MARK	DATE	DESCRIPTIONS	BY	CH'D	CCO#
1	02/01/11	BRACKETS FOR FUTURE LIGHT PIPES	TS	JB	182

DETAILS
SAS SUPERSTRUCTURE ROADWAY WESTBOUND
TYPICAL LIGHT PIPE INSTALLATION 1

SAN FRANCISCO OAKLAND BAY BRIDGE
EAST SPAN SEISMIC SAFETY PROJECT
SELF-ANCHORED SUSPENSION BRIDGE
(SUPERSTRUCTURE & TOWER)

REMOVAL OF BRACKETS FOR FUTURE LIGHT PIPES

DETAILS
SAS SUPERSTRUCTURE GIRDER EASTBOUND
TYPICAL LIGHT PIPE INSTALLATION 1

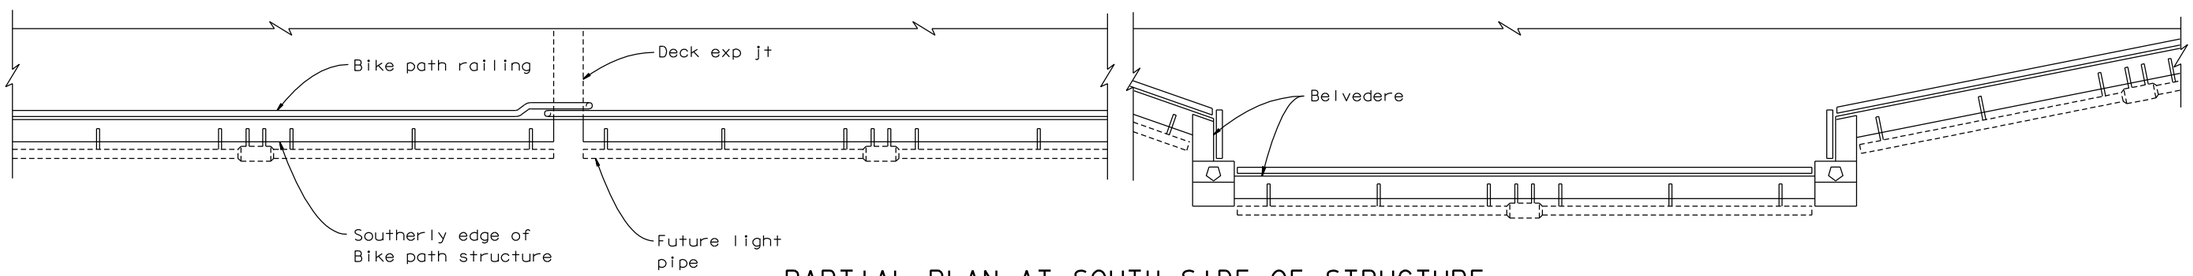
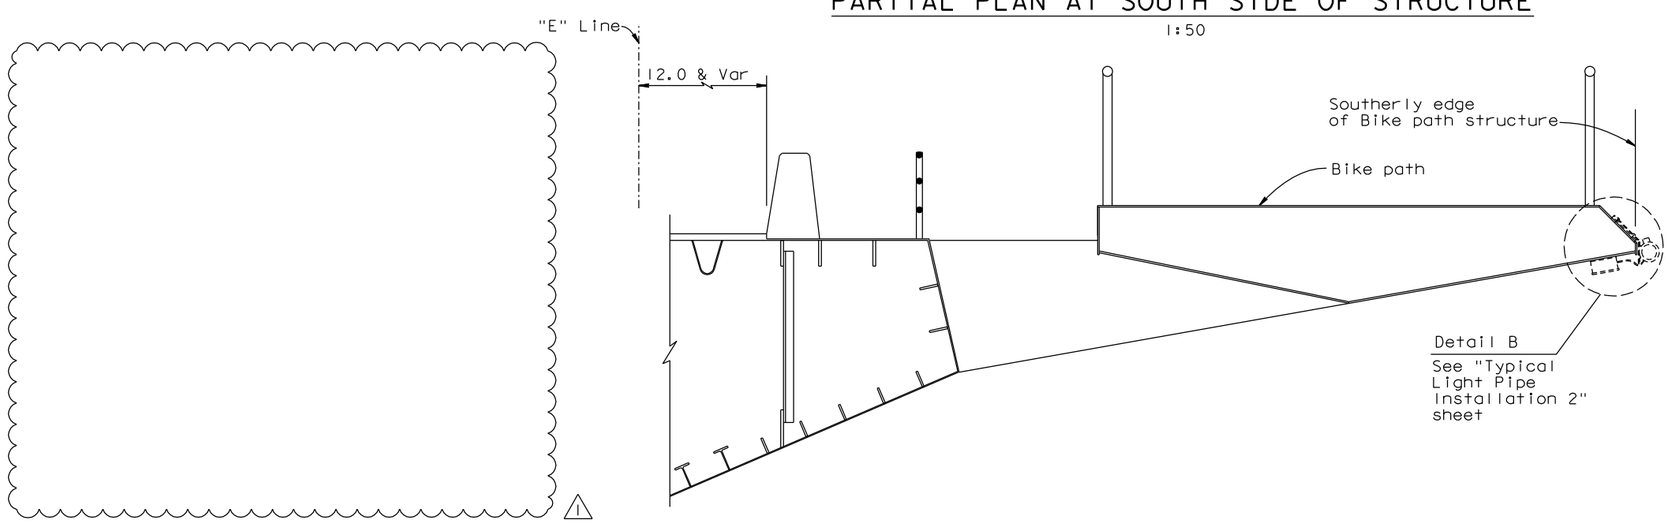
MARK	DATE	DESCRIPTIONS	BY	CH'D	CCO#
1	02/01/11	BRACKETS FOR FUTURE LIGHT PIPES	TS	JB	182

LIGHTING DETAILS NO. 2

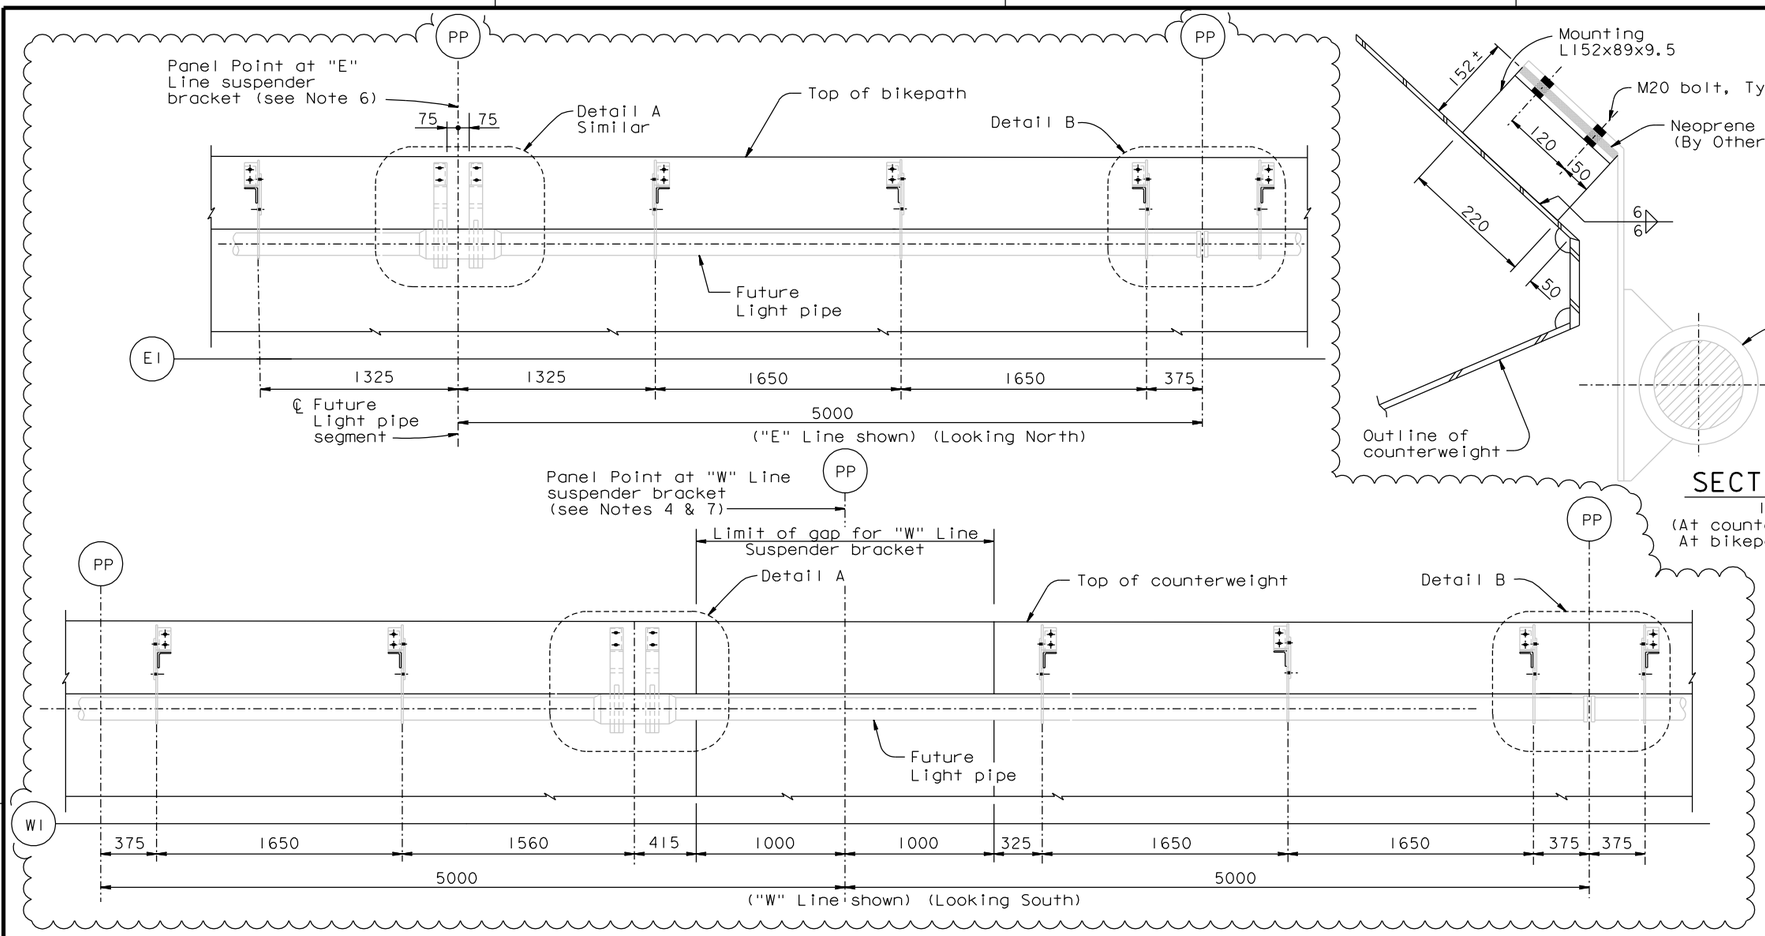
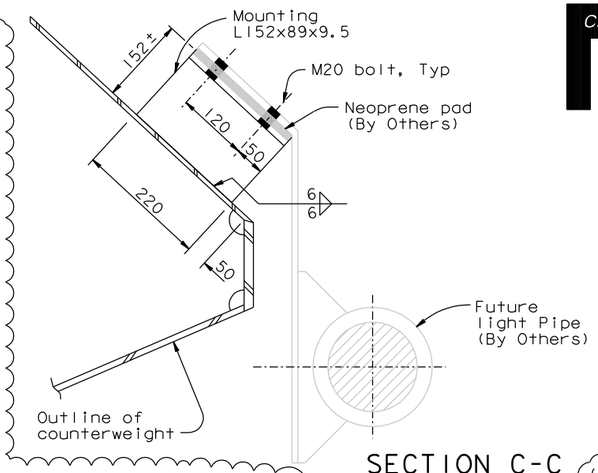
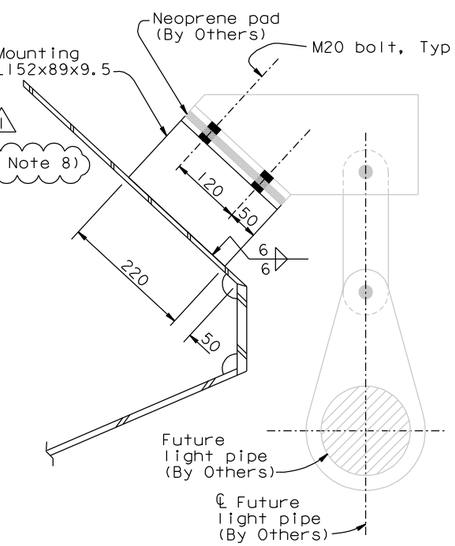
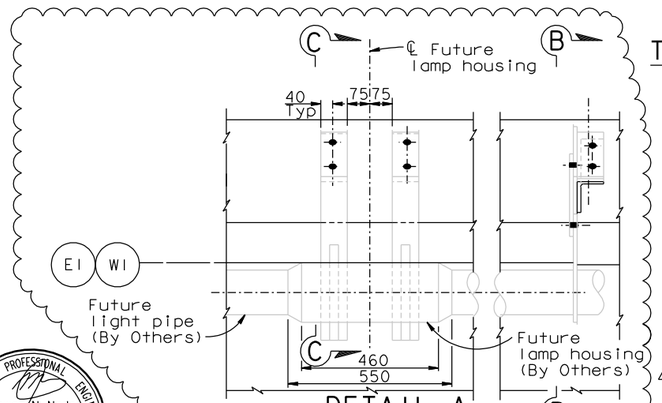
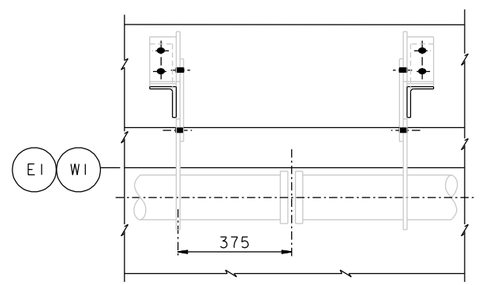
MARK	DATE	DESCRIPTIONS	BY	CH'D	CCO#
1	02/01/11	BRACKETS FOR FUTURE LIGHT PIPES	GB	MN	182

1. Details shown for counterweight side. Bikepath side similar.
2. Mounting angles shall be installed. Future light pipe and appurtenance by Others.
3. Provide all bolts to be installed in open holes.
4. Support for future light pipe is shifted to avoid counterweight gap.
5. Light pipe support spacings are taken to the back of the mounting angles.
6. Provide lamp housing brackets at even panel points 6 through 126.
7. Provide lamp housing brackets at even panel points 8 through 104.
8. For mounting bracket removal procedures, see "Lighting Details No.3" sheet.

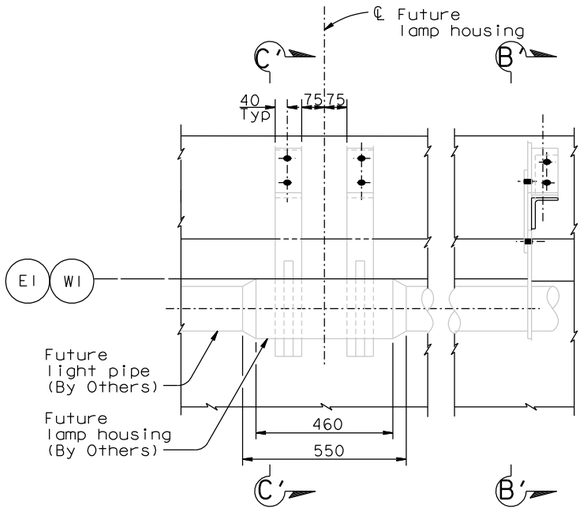
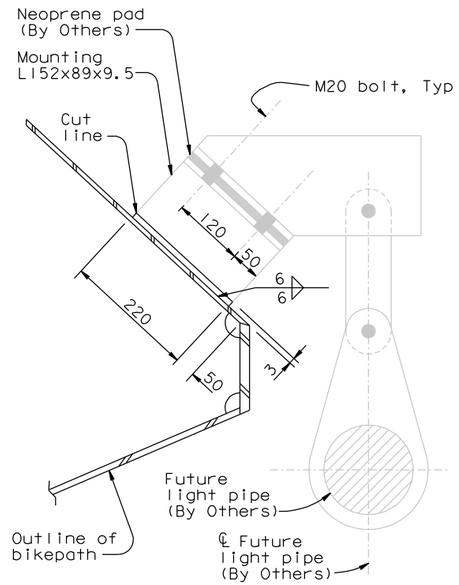
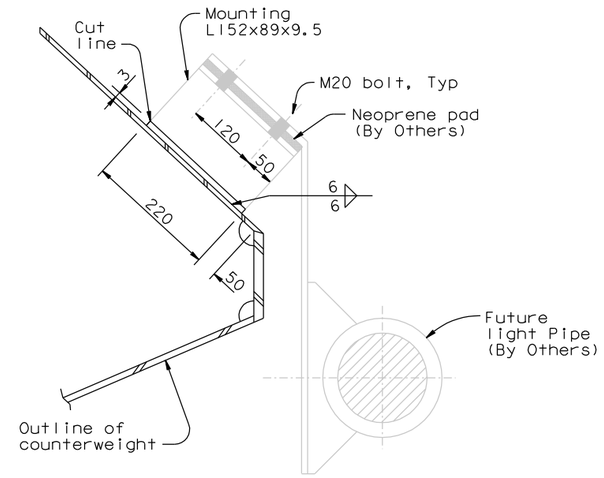
MARK	DATE	DESCRIPTIONS	BY	CH'D	CCO#
0	02/01/11	BRACKETS FOR FUTURE LIGHT PIPES	JD	MN	182

1. Cut mounting bracket a distance of 3 mm from bikepath or counterweight, or as otherwise approved by the Engineer.
2. Grind angle down flush with bikepath or counterweight.
3. Clean and paint bikepath or counterweight.
